Subject: Amendment #1 to Request for Proposals (RFP) No. RAM-7-77539,
"Independent Testing of Small Wind Turbines"

This notice comprises Amendment #1 to the subject Request for Proposals (RFP), which provides NREL's responses to the technical questions received. Please note that questions may have been edited for clarity, to protect business-sensitive information, or in some cases combined with similar questions to enable comprehensive responses.

Figure 1 Wind direction distribution, NWTC

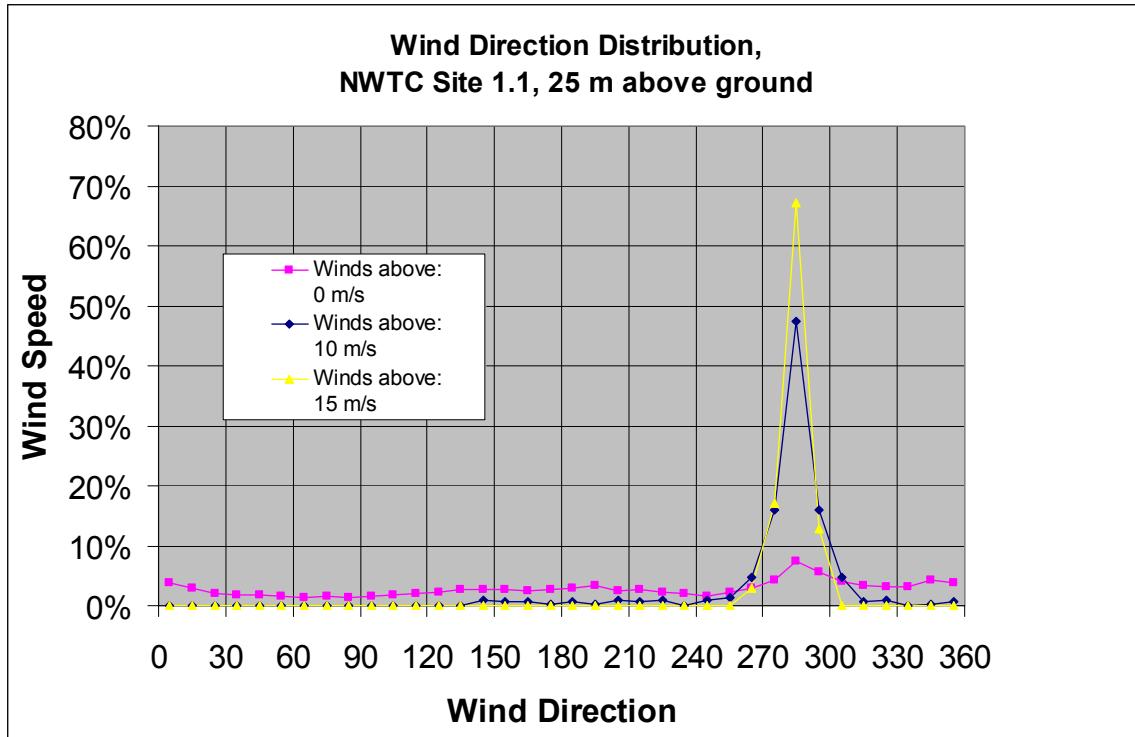
- Q12. What is the directional nature of the wind resource at the test site? Is there a strongly prevailing wind direction?*
- A12.** Prevailing winds are from the NW as shown in Figure 1 below.
